CITY FILE NUMBER	CHANGES TO PLANS	APPROVAL DATE
CPC DP 02-0253	Beth-El Mennonite Church Development Plan	(2002)
AR NV 09-00036	nonuse variance for additional wall signage	(2009)
PDZ-25-0020	minor modification to add preschool use	(Summer 2025)

Beth-El Mennonite Church

4625 RANCH DRIVE COLORADO SPRINGS

PDZD-25-0020

LS1

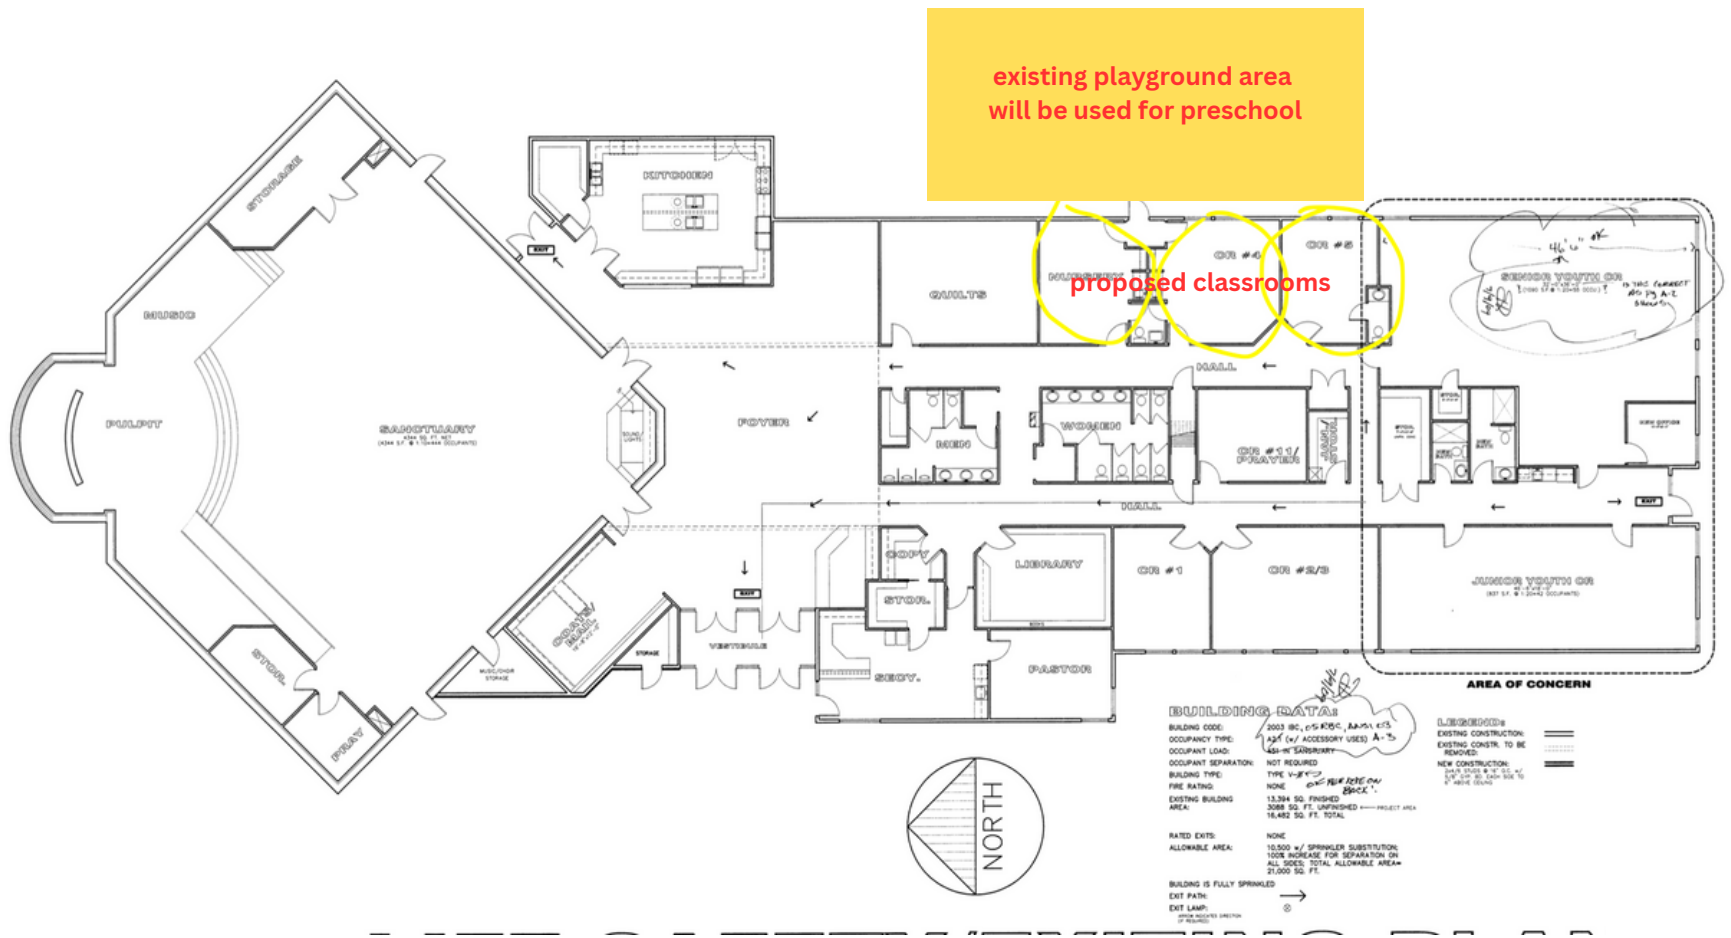
existing playground area
will be used for preschool

proposed classrooms
